## 4. Revisions to the Draft EIR

This chapter presents the revisions made to the Draft Environmental Impact Report (EIR) in response to comments. The changes and additions to the Draft EIR do not raise important new issues about significant effects on the environment. The changes are “insignificant” as defined in Section 15088.5 of the California Environmental Quality Act (CEQA). Revisions to the Draft EIR are organized by section and page number. Revisions are denoted by strikethrough (~~strikethrough~~) where existing text was removed and underline (underline) where text was added.

Figure C-2.2  
**Proposed and Alternative  
 Route Segments**

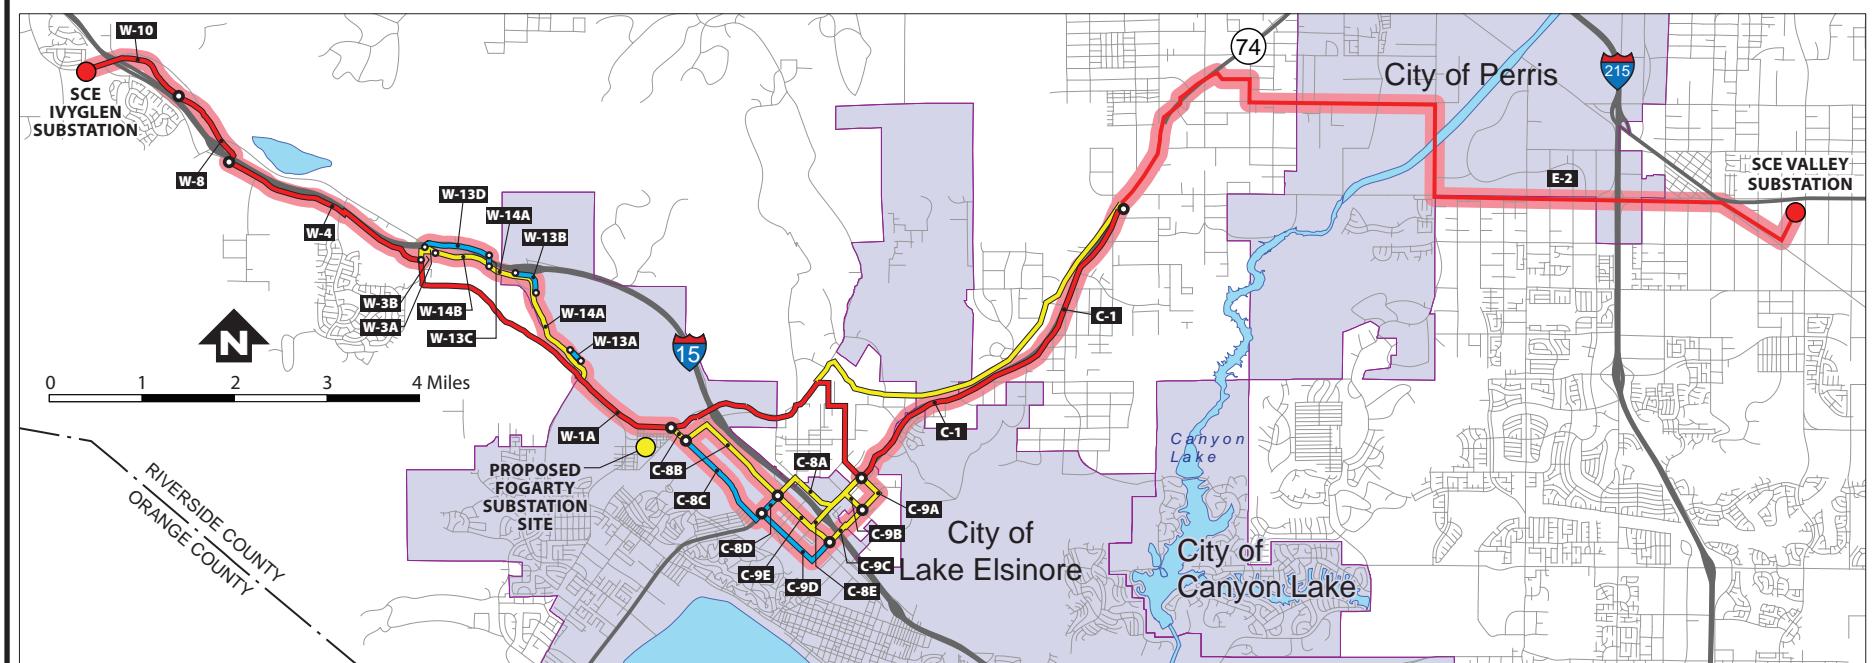
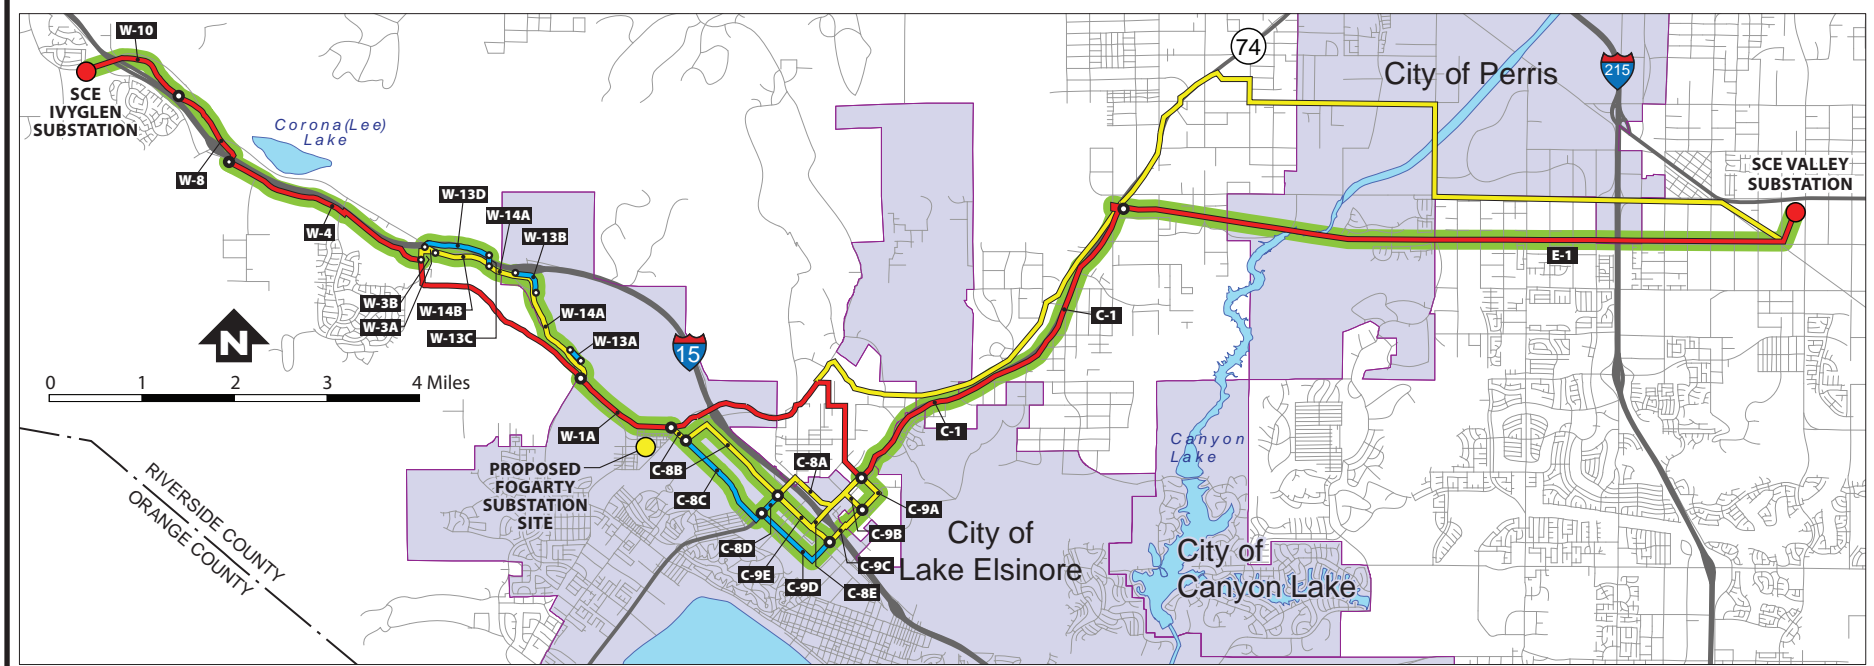
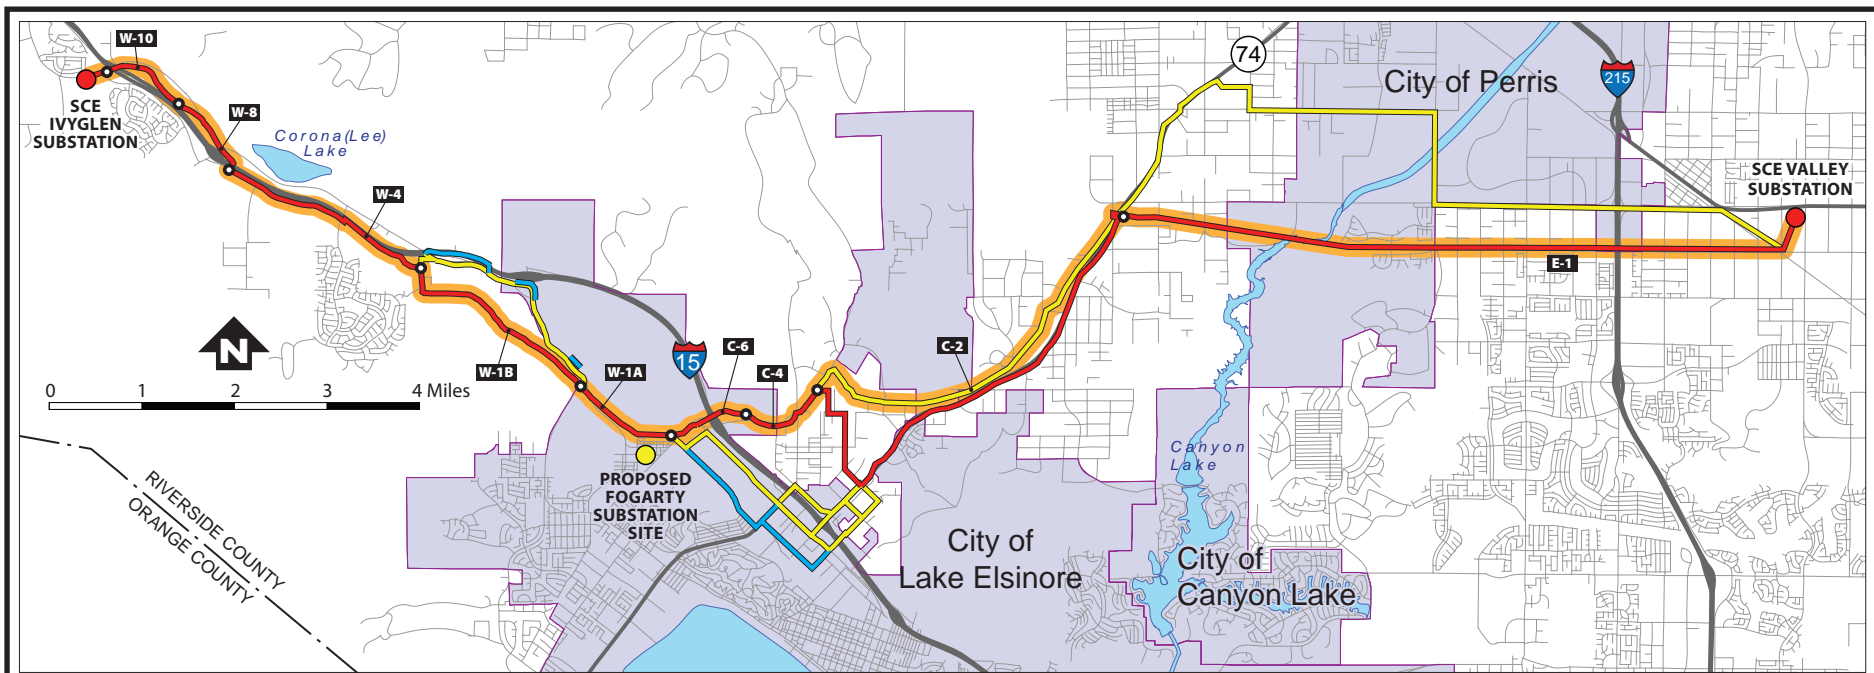
These alternatives and their environmental impacts compared to those from the Project are individually discussed in Chapter E, Comparison of Alternatives. Figure C.2-2 (Section 4.11, Revised Figures, of the Final EIR) indicates which alternative route segments were carried forward for analysis in Chapter E.

The following Draft EIR figures were revised as a result of responses to comments.
